# Access Compliance Report

## Public Rights-of-Way

### (Curb Ramps)

Intersection ID: 48448	Main Street: DUSTY_SADDLE_RD	Cross Street: BURNT_LEATHER_LN	Location: E
ADA ID: DA57E8137B3F	Ramp Type: BlendTrans1	Initial Pass/Fail: Fail	Overall Compliance: No
Severity Score: 12.5			
Codes/Mitigation Info/Possible Solution		Field Measurements/Component Compliance

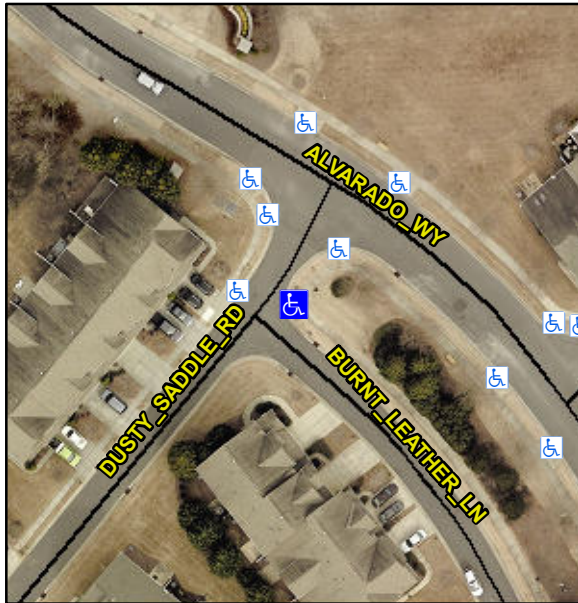
**Not Found, R304.5.3**

Compliance	Description	Data	Compliance	Description	Data
N/A	Ramp Length (in)	71.0	Yes	BlendTrans Slope (%)	4.9
Yes	Ramp Width (in)	48.0	No	BlendTrans XSlope (%)	5.1
N/A	Flare Type LT	N/A	N/A	Flare Type RT	N/A
N/A	Flare Slope LT (%)	N/A	N/A	Flare Slope RT (%)	N/A
N/A	Flare Traversable LT?	N/A	N/A	Flare Traversable RT?	N/A
N/A	Landing Length (in)	N/A	N/A	DWS Provided?	N/A
N/A	Landing Width (in)	N/A	N/A	DWS Contrast?	N/A
N/A	Landing Slope (%)	N/A	N/A	DWS Length (in)	N/A
N/A	Landing X Slope (%)	N/A	N/A	DWS Full Width?	N/A
N/A	Landing Curb? (Y/N)	N/A	N/A	DWS Offset (in)	N/A
N/A	Shared Landing?	N/A			
N/A	Gutter Ponding?	N/A	N/A	Gutter Slope (%)	N/A
N/A	Gutter Lip Ht (in)	N/A	N/A	Gutter X Slope (%)	N/A
N/A	Painted X Walk1?	No	N/A	Painted X Walk2?	No
	X Walk 1 Direction	To NW		X Walk 2 Direction	To SW
	X Walk 1 Width (in)	N/A		X Walk 2 Width (in)	N/A
	X Walk 1 Slope (%)	2.0		X Walk 2 Slope (%)	0.7
	X Walk 1 X Slope (%)	0.5		X Walk 2 X Slope (%)	0.6

N/A	Ramp inside XWalk1?	N/A	N/A	Ramp inside XWalk2?	N/A
	Road Slope (%)	0.7		Clear Space?	N/A
	Road X Slope (%)	1.0	N/A	Clear Space to XWalk (in)	N/A
N/A	Any Obstructions?	N/A	N/A	Storm Grate/Utility Hazard?	N/A
	Obstruction Type			Storm Grate/Utility Type	
		N/A			N/A
			Yes	Surface Condition? (G/P)	Good
			No	Curb Slope (%)	8.4

**Remove & Replace Curb Ramp With Two New Directional Ramps or Equivalent.**
